GROUND-TRUTH AUSTRALIAN ORCHARDS VALIDATION REPORT

Project Title	Ground-Truth Australian Orchards (Project ID: 4118)
Version	2.0
Report ID	CCIPL1593/VCS/VAL/GTAO/20221006

Report Title	Ground-Truth Australian Orchards Validation Report
Client	Carbon Friendly Pty Ltd
Date of Issue	29-November 2023
Prepared By	Carbon Check (India) Pvt. Ltd.
Contact	Regd. Off: 2071/38, 2 nd Floor, Naiwala, Karol Bagh, New Delhi – 110005

KML files of sampling points and control sites

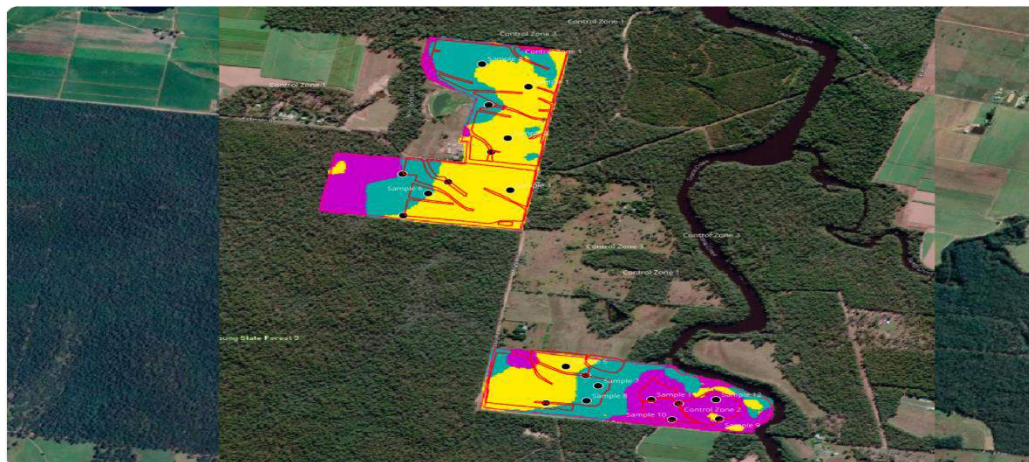
Project participant response				Date: 05/09/2023
We have added detail on the control sites in section 4.1 and added the baseline control site management plan to section 5.3.

Further for baseline control sites, PP has provided explanation in the section 3.6 of the VCS PD stating the requirement for the methodology deviation. The project proposes a deviation from the VM0042 v2.0 methodology due to its conversion from the previous version, VM0042 v1.0., as the proposed project predates the updated methodology and requirements for control sites therein.

Format of spreadsheet provided by PP:

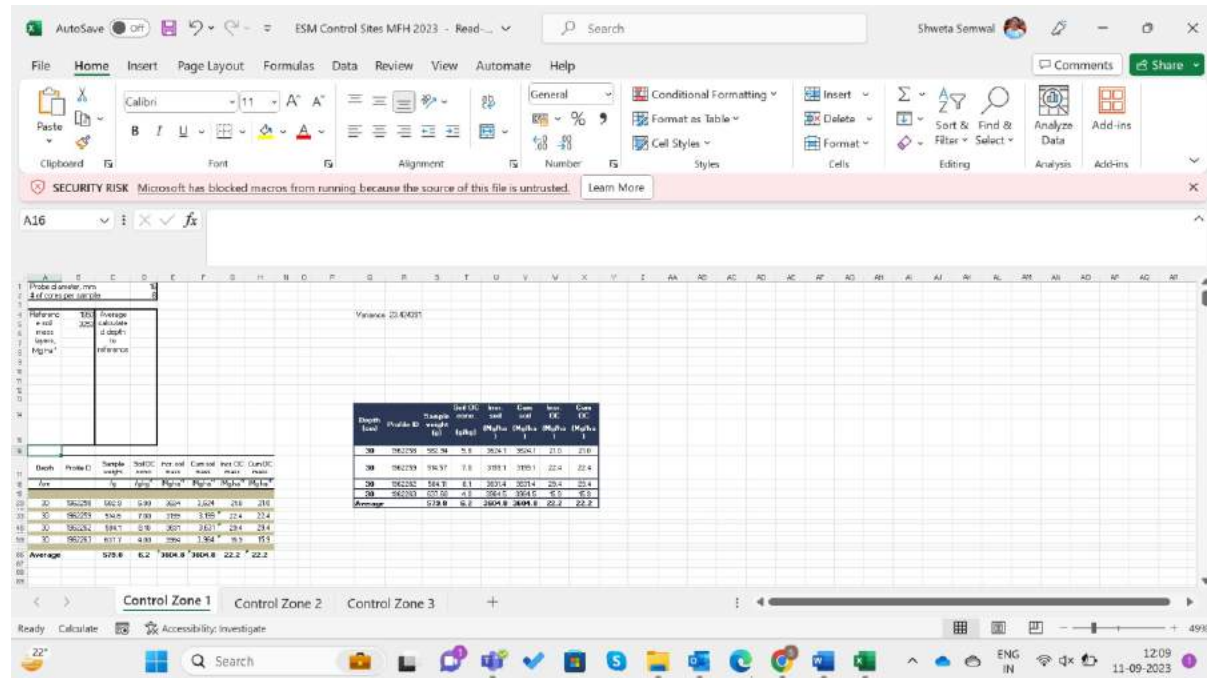
PP has provided details on requirement and sample design for soil sampling and soil sample calculation methodology in supplementary document i.e., **CF_SOP_Soil Sampling_V1.4_2023.08.16.pdf**. PP has further provided the same in the revised VCS PD v2.0 under section 5.3.1.

PP has provided justification for selecting the Walkley Black method for baseline SOC calculation in section 5.3.1 of the VCS PD.

PP has provided the requested spreadsheets including baseline and project SOC calculations in line with requirement of section 8.2.1.6 of the applied methodology.
